**TOWN OF BALLSTON PLANNING BOARD
REGULAR MEETING MINUTES
January 26, 2022
via Zoom Only
6:30 pm**

60 Middleline Rd CSI (PB 2021-011)

Site Plan Review and Special Use Permit for Community Solar Installation (CSI) - *Proposal of 5 MW AC CSI.*

Option 1 – all area encompassed by the solar panels (in yellow): This is approximately 22.2 acres or 35.3% coverage (exceeds zoning max of 20%).

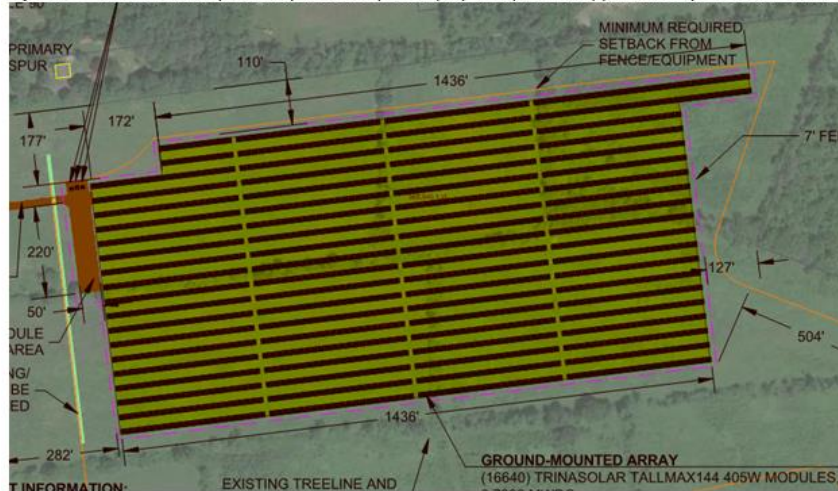
Ms. Lippmann stated that the zoning code is written as “system perimeter coverage”. Ms. Lippmann stated that she included the panel perimeter area but did not include the fencing perimeter. Ms. Lippmann stated that she had received Mr. Stickles’ interpretation that the coverage perimeter was the outside perimeter of the system as shown in the first figure below.

Ms. Lippmann showed two figures on the screen to illustrate how the coverage is being interpreted. The first picture shows the perimeter of the system and she received concurrence from Mr. Stickles as to the interpretation of the code. The coverage calculated as shown is 35.3% and because of the way the code is written, this is the way it was intended.

Ms. Lippmann stated that the path forward is an area variance if the application cannot be modified to reduce the coverage.

Option 2 – Only the surface area of the panels is calculated (in yellow). This is approximately 7.35 acres or 11.7% coverage and meets zoning.

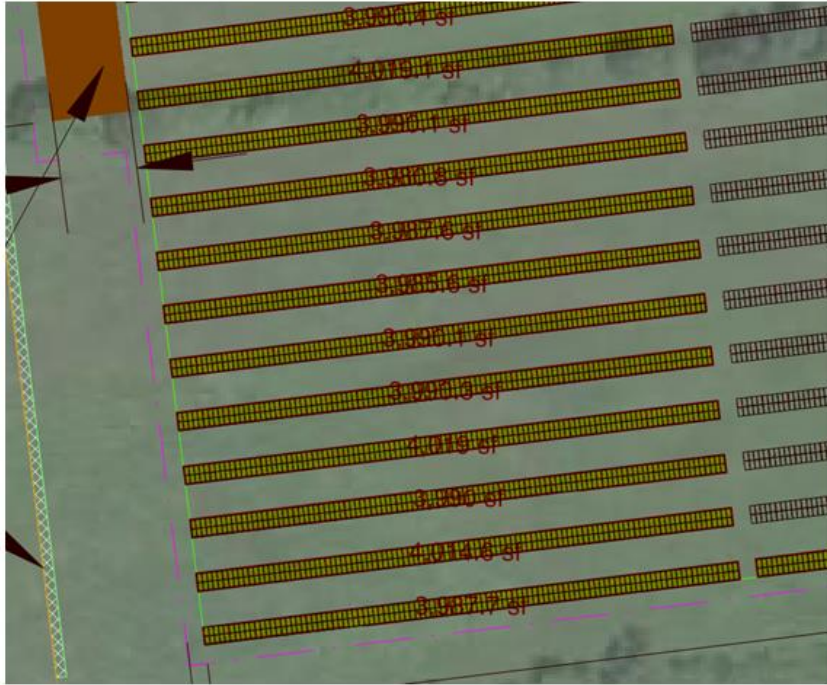
Ms. Lippmann stated that if the interpretation were to be taken a different way to include just the surface area of the panels, then Mr. Ruthmann’s project would be at 12% coverage and the requirement would be satisfied.
